# Town of Franklin

**Re: 1199 West Central Street – Garelick Farms  
MassDEP File No. 159-1322  
Notice of Intent Peer Review #2**

BETA Group, Inc. (BETA) has reviewed revised documents and plans for the project entitled **Garelick Farms Flood Resiliency Improvements** (the Project), located at **1199 West Central Street** (the Site) in Franklin, Massachusetts. This letter is provided to present BETA's findings, comments and recommendations.

# FRANKLIN, MA GARELICK FARMS FLOODING RESILIENCY IMPROVEMENTS

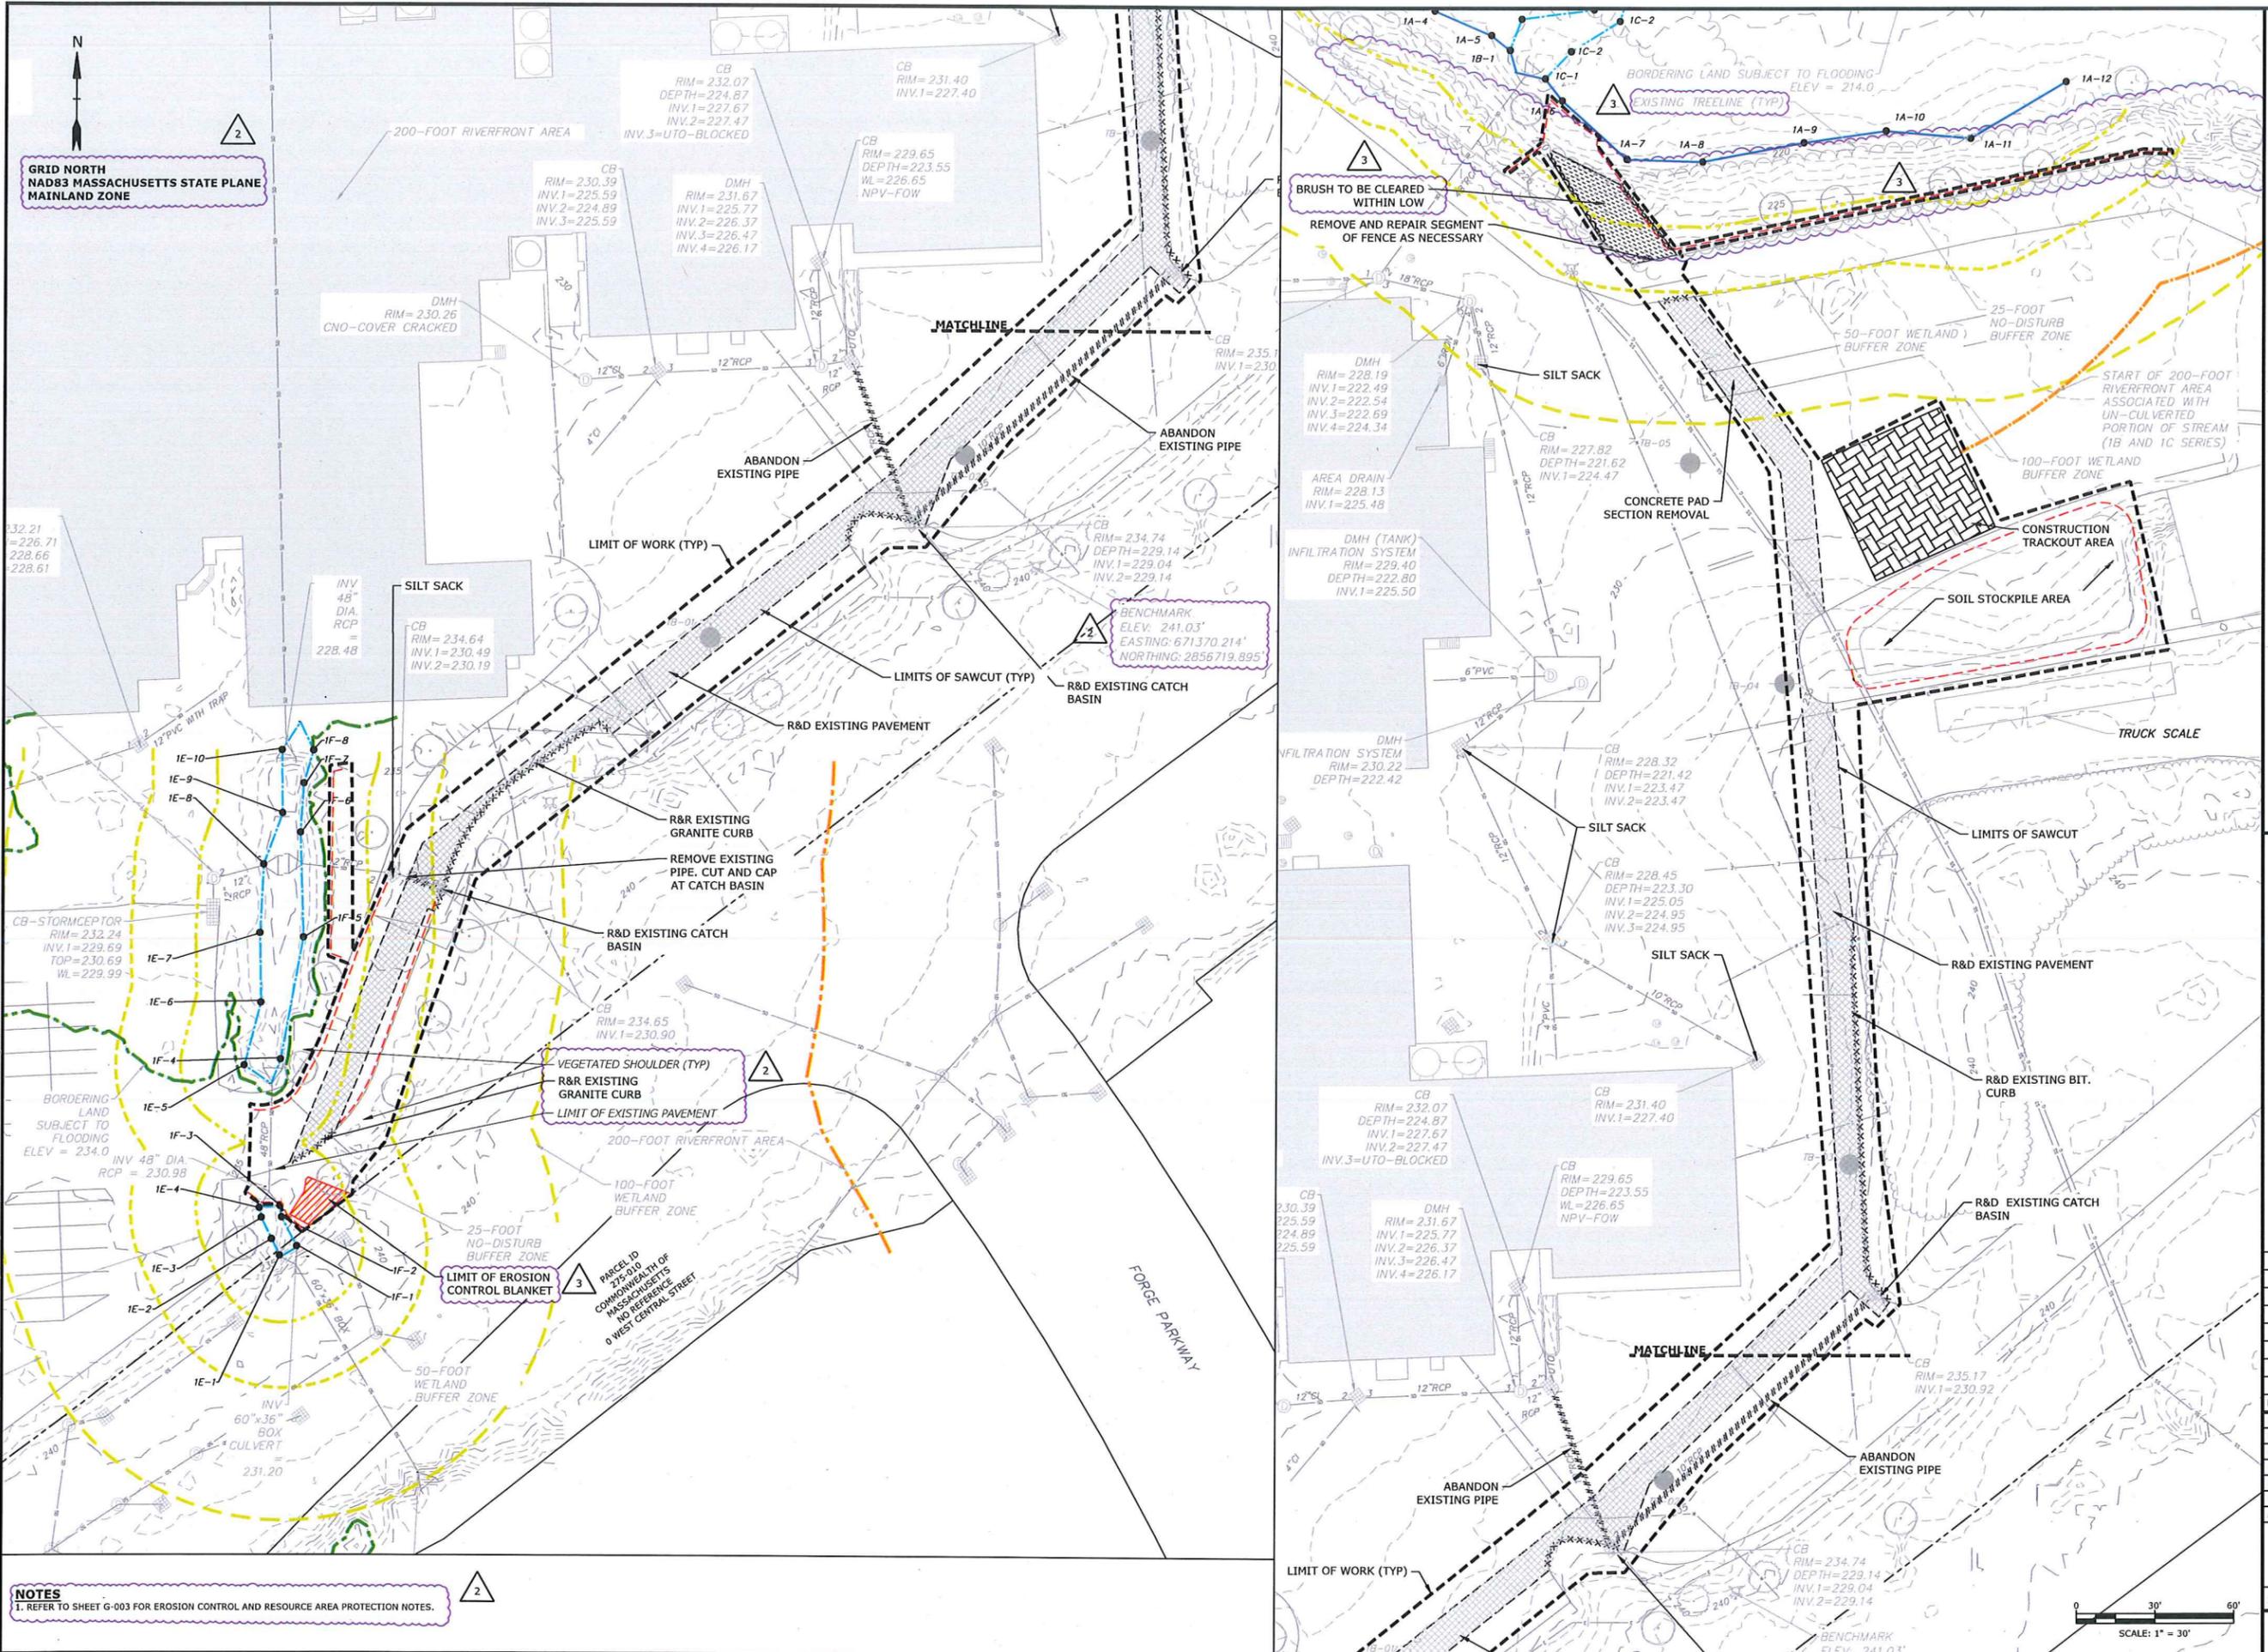
**BETA2: Comment remains. The existing/proposed conditions tree lines are not depicted along the northern portion of the Site adjacent to the 1A Wetland Series where trees are present. The existing conditions plan appears to show a tree line in this area, but it does not encompass the locations of the individual trees that are depicted. The site plans depict a tree line in this area with a proposed conditions line weight, but it does not appear to correlate with the proposed clearing for the headwall. The tree lines should be revised as appropriate.**

- W4. Resource Area impacts (both permanent and temporary) should be clearly depicted on the plans. The Applicant should confirm if Bank impacts are required as work (including limits of work/erosion and sedimentation control installation) appears to overlap with Bank along flag 1F-3.

**T&B2: The existing/proposed tree lines have been added to the project plans in the area of the proposed drainage pipe and outfall installation. A note has been added on sheet C-102 to indicate that brush will be cleared within the limit of work in the area. The proposed condition tree line referred to in BETA's second round review comment appears to be the revision cloud used to indicate changes throughout various iterations of plan sets. To clarify the difference, revision clouds have been changed to purple.**

*T&B: A benchmark has been added to sheets C-102 and C-201.*

*T&B: Labels have been added to the Site Plans for the limits of existing pavement and vegetative shoulders. See sheet C-102.*

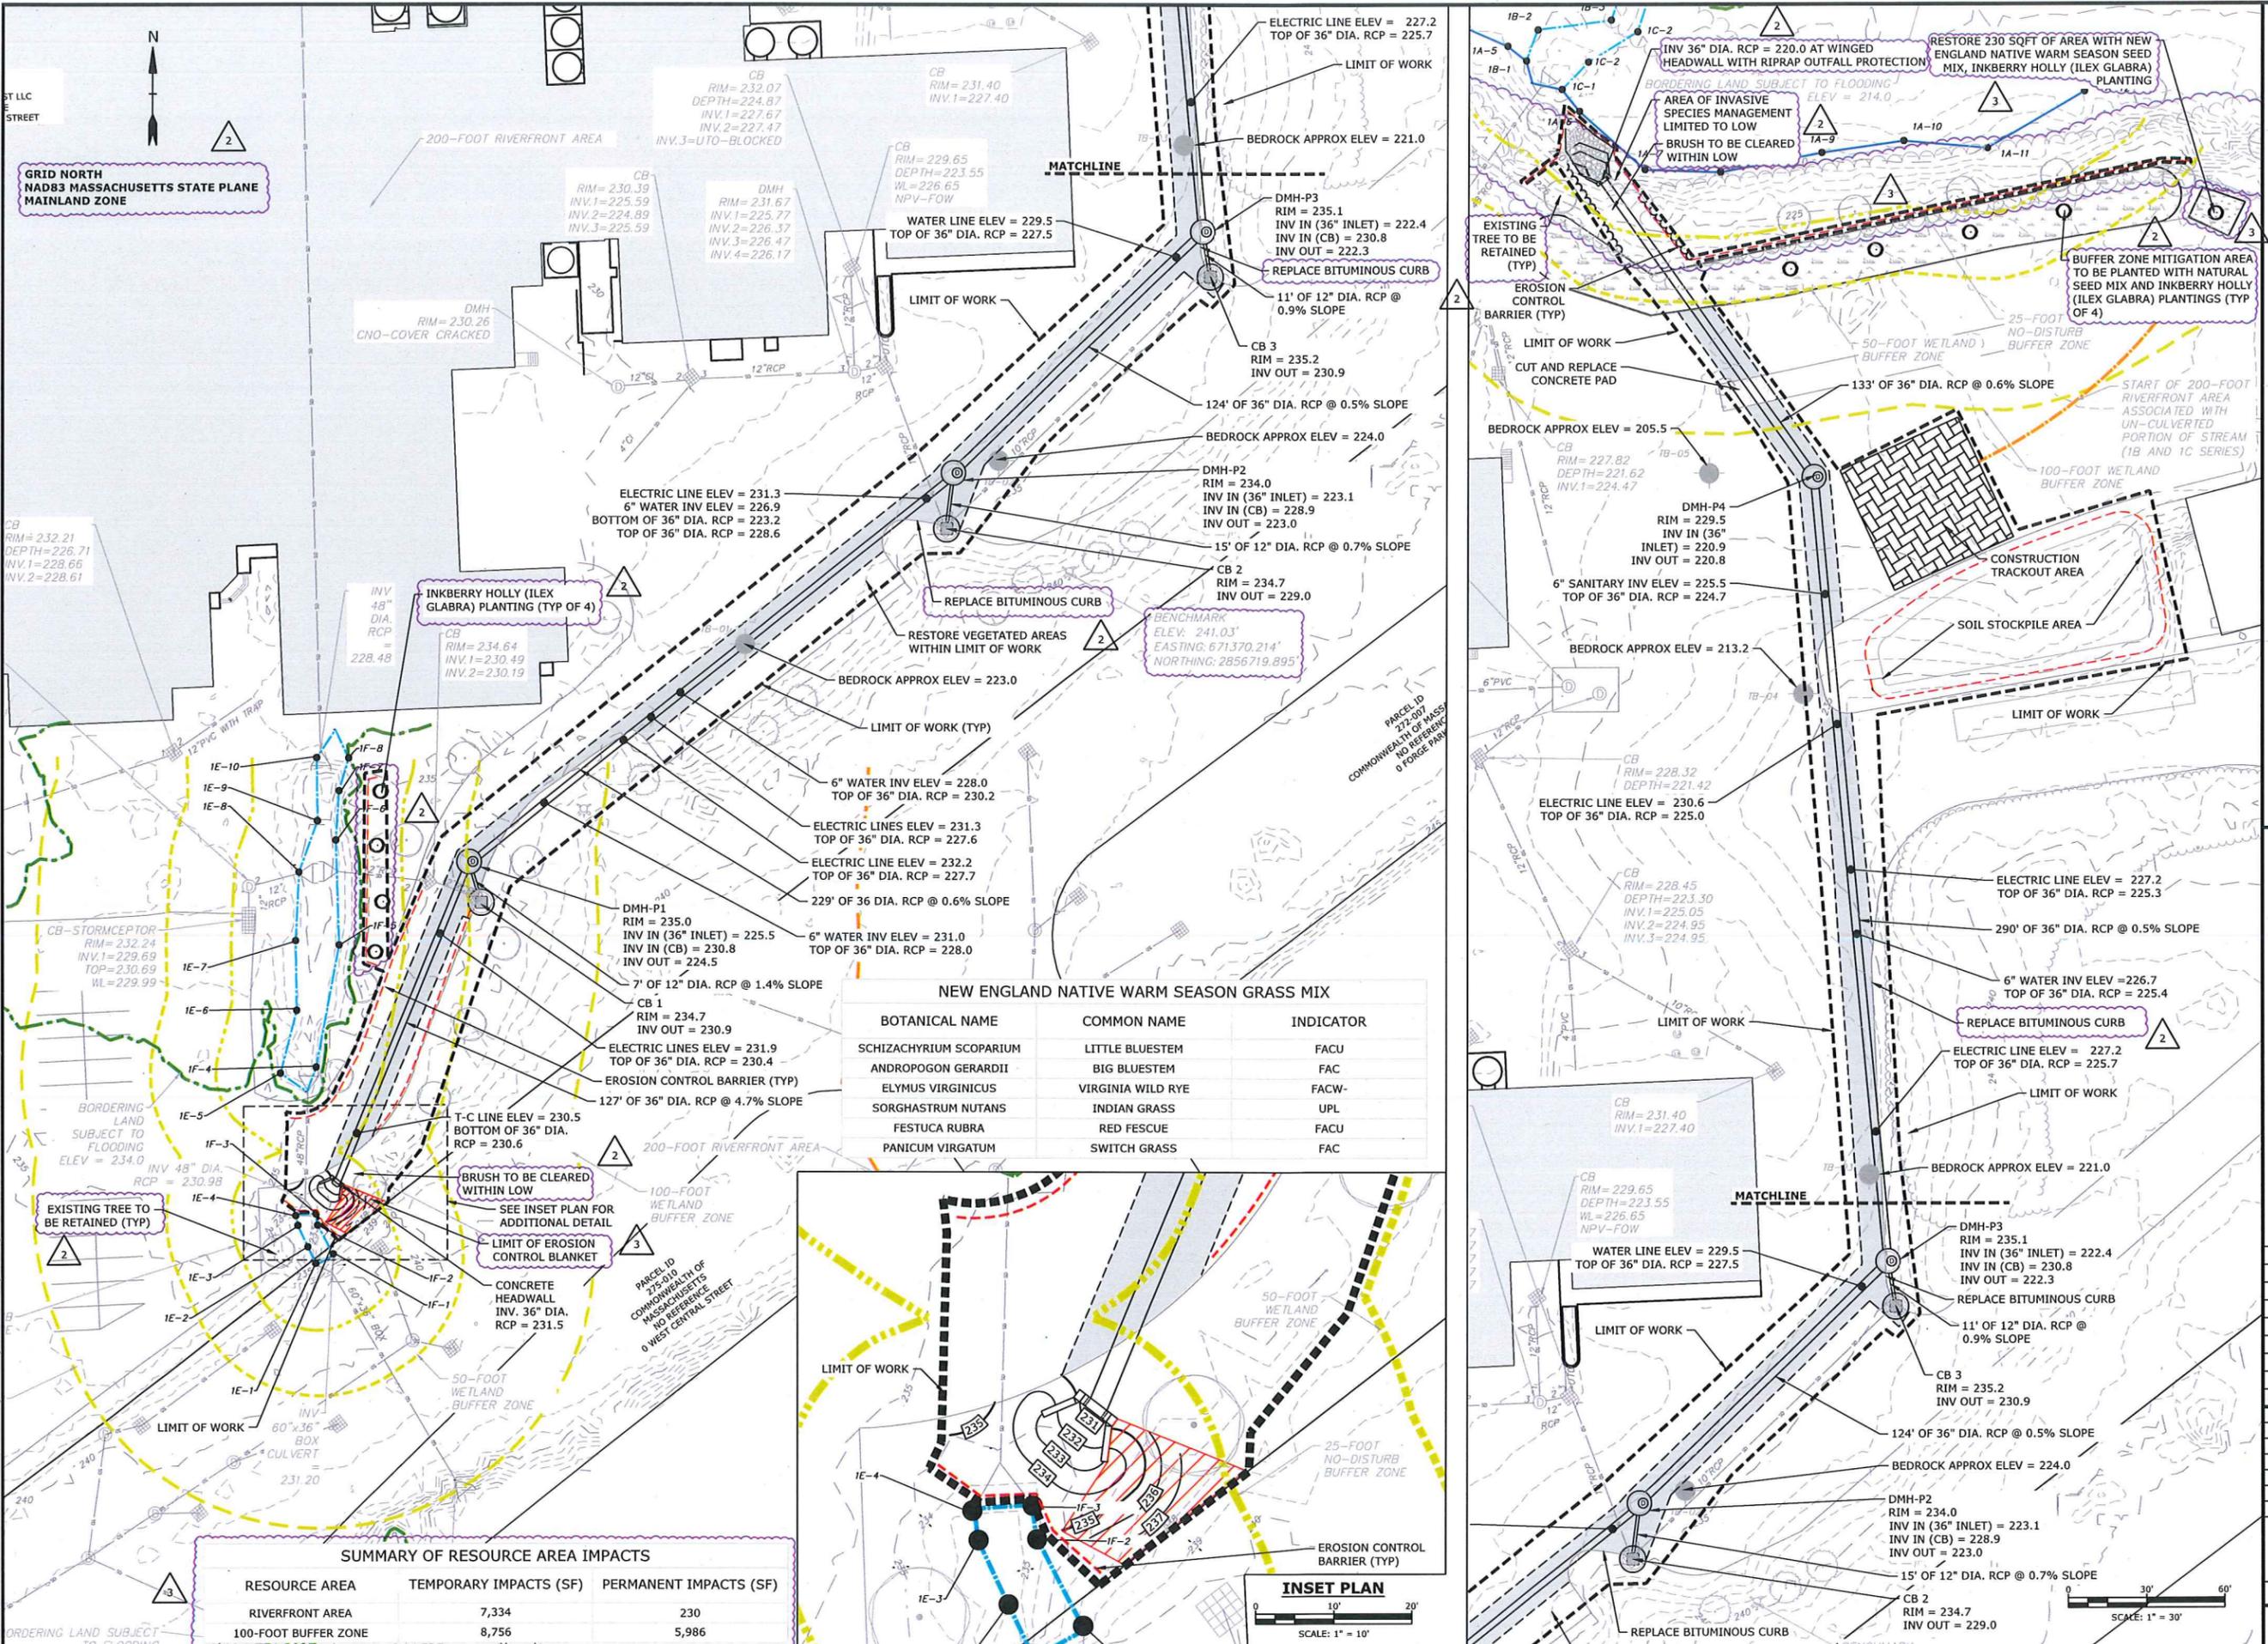
**BETA2: This comment has been addressed with regard to potential Bank impacts. However, the depiction of Resource Area impacts on the plans has not been addressed. In lieu of callouts, the Applicant could consider including the impacts table from the comment response letter on the plans.**

**BETA2: Permanent impacts to RA have increased from 50 sf to 230 sf according to Table 5-1 Summary of Resource Area Impacts. The Applicant should provide the total area of restoration to ensure that sufficient restoration is being provided for the updated impact totals. In addition, BETA notes that the "New England Native Warm Season Grass Mix" or similar seed mix should be applied to all restoration areas.**

- SW3. The flared end section at the end of the proposed 36-inch pipe run discharges to a 3:1 ( $\pm$ ) slope. Additionally, the flared end section is oriented at an angle that is not perpendicular to the slope, which will render the riprap less effective. BETA recommends that the angle of the outlet pipe be reevaluated, and a concrete headwall be utilized to provide an effective flat area where the riprap can dissipate flows and prevent scouring.

*TB: Selective clearing and grubbing of vegetation will be required within Buffer Zone for the installation of the proposed headwall, outfall, and portions of proposed pipe. Removal of trees is not anticipated to be required for this work. A callout has been added to the drawings on sheet C-201 to identify this work.*

*TB: The location of the proposed outfall was selected based on the required outfall elevation and relative proximity of the nearby wetland resource area. A system outlet elevation of 220.0 is required based on upstream drainage system elevations, as well as hydraulic pipe capacities. A perpendicular orientation of the proposed flared end section cannot be achieved at elevation 220.0 without direct impacts to wetlands. However, a winged headwall has been added to the project plans to allow for a flatter grade at the outlet, and adjustments to the riprap outfall protection configuration have been made. See sheet C-201 for updated outfall information.*

### **T&B2: A summary of resource area impacts table has been added to the plans on sheet C-201.**

**T&B2: The total area of restoration has been revised to 230 sf on the project plans. As noted on the drawings, the restoration areas will be seeded with the New England Native Warm Season Grass Mix as noted on revised Sheet C-201.**

**EROSION CONTROL BARRIER**  
NO SCALE

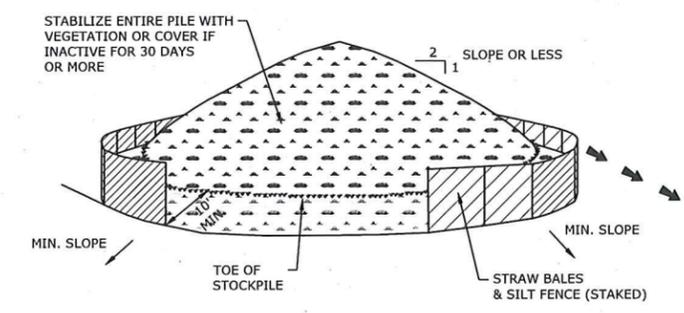
**BETA2: BETA defers to the Commission on the approval of the use of straw wattles as erosion controls, as they have discouraged their use in recent years. The use of silt fence and hay/straw bales is referenced within the soil stockpile detail on page C-501 within Section 3.3 of the O&M Plan and should be revised accordingly.**

### **T&B2: The detail on sheet C-501 has been revised to indicate the use of compost filter tubes, and the O&M Plan has been updated to remove references to straw wattles.**
